**NUMBER:** 23-005-21

Front Seat Side Shield Updated Service Procedure

2014 - 2019 (KL) Jeep Cherokee

**Fig. 1**  
**Back Side Shield Hole Being Elongated**

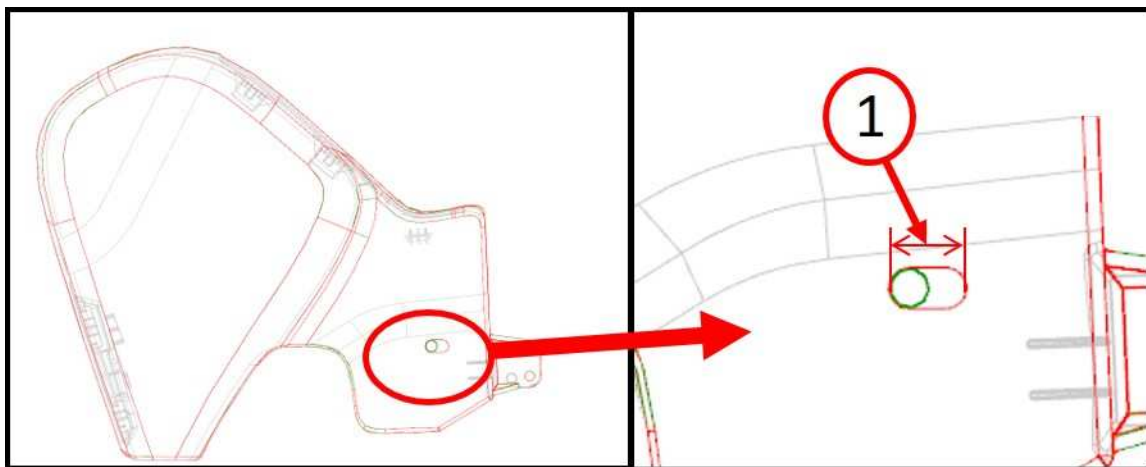
2. Remove inboard side shield. Refer to the detailed service procedures available in DealerCONNECT/Service Library under: Service Info 23 - Body / Seats, Front / Side Shields, Seat, Manual (or Power) / Removal.
3. Use a hand held rotary multi use tool or a file (Fig. 1) to elongate the hole to 12.5 mm (.5 in) slot (Fig. 2) .

1 - Use a hand held rotary multi use tool or a file to Elongate Hole.

1 - 12.5 mm (.5 in)
